RESOLUTION OF THE ONONDAGA COUNTY PLANNING BOARD

OCPB Case # Z-18-26

REFERRAL COMMENTS

Variance (Area): V-18-06
Address: 113 PARK AVE, Syracuse,

J.R.L. Land Surveying, PLLC
 Topographic Survey on part of Lot No. 1 - Block No. 71, City of Syracuse
 Known as No. 113 and 115 Park Avenue, City of Syracuse, County of Onondaga, State of New York.
 Scale: 1" = 20' Date: 09-08-17 Drawn By: JRL

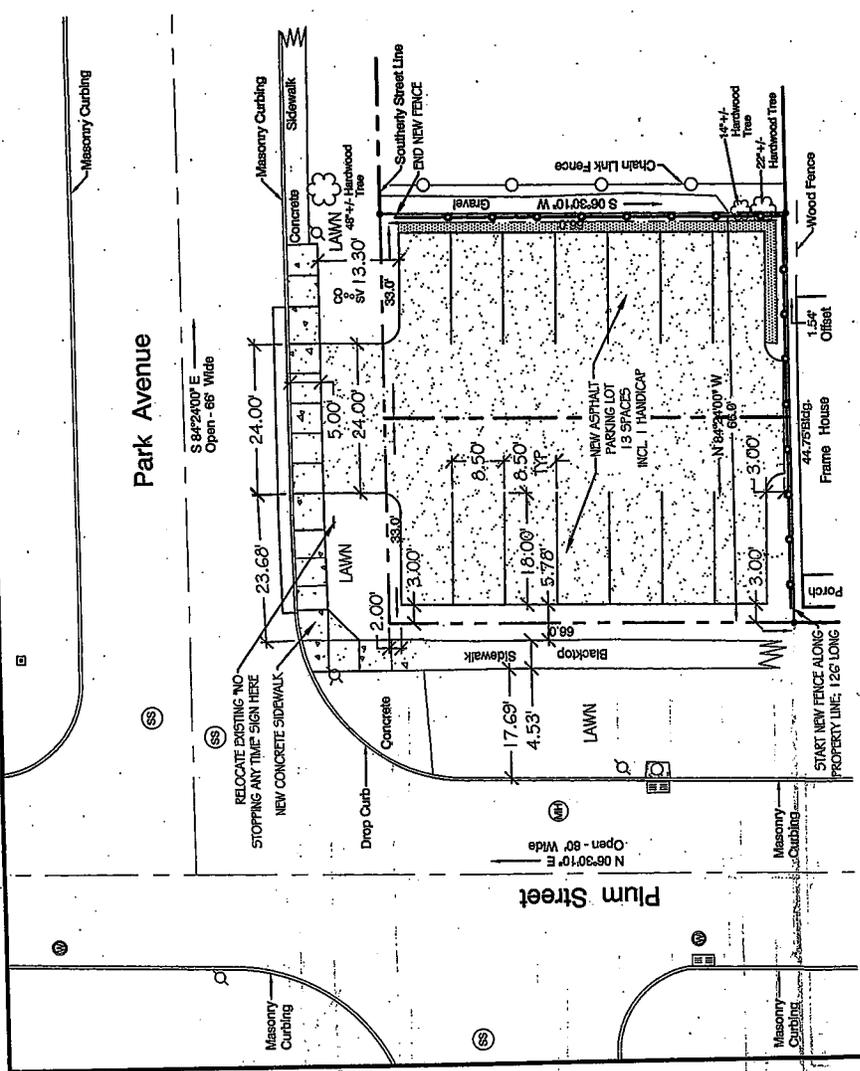
WHEREAS, the submitted Grading and Drainage Plan dated December 26, 2017 shows a 2' wide infiltration trench along the eastern lot line and a portion of the southern lot line; and

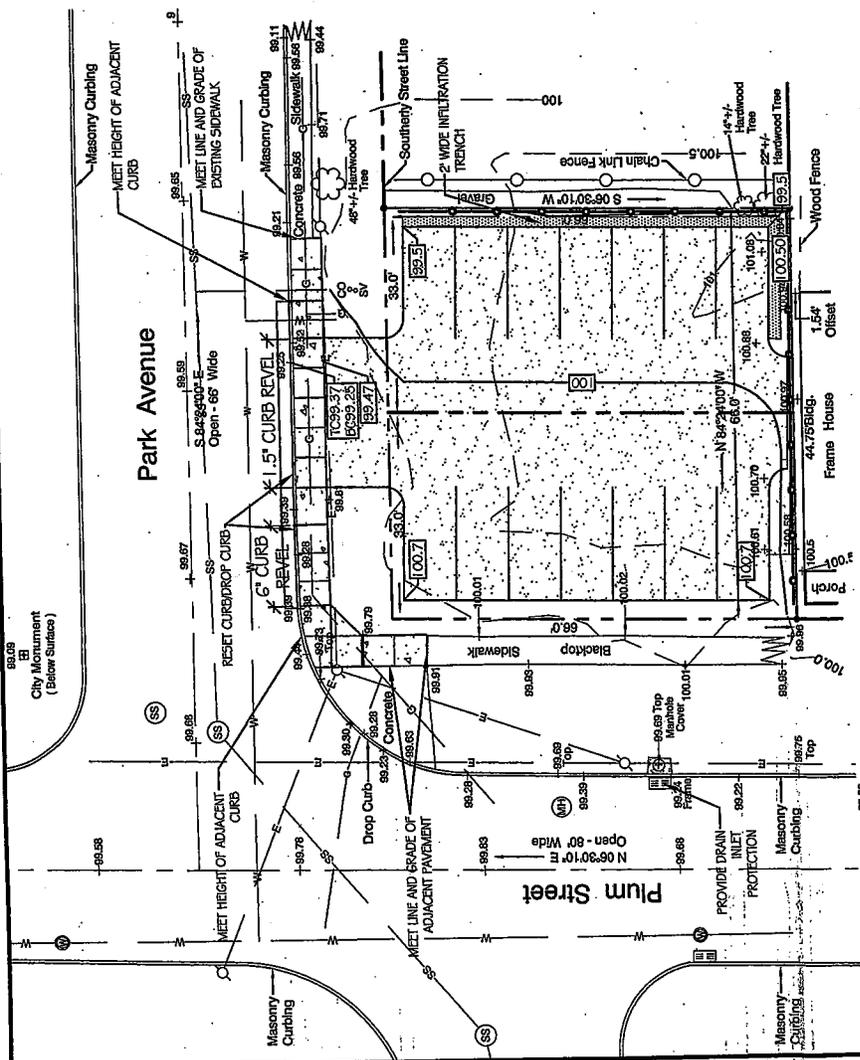
1. The grading plan currently shows sheet flow of storm water being directed to the City ROW and adjoining properties. The grading plan shall be revised so that all Storm water / Roof Drainage is contained on site.
2. The Southern edge of the proposed parking lot shall be revised to be straight along the whole length. There shall be a continuous and consistent buffer of green space between the proposed parking lot and all adjoining properties.
3. Plans do not show/label the material between the proposed parking lot and the sidewalk.
4. The City recommends replacing all blacktop sidewalks with concrete sidewalk per City standard.
5. Sidewalk shall be installed per City, NYSDOT standard and comply with current ADA standards (2% cross slope maximum, 5' x 5' flags, etc.). Proposed sidewalk shown on plans is designed at the maximum cross slope.
6. Resubmit plans addressing comments.
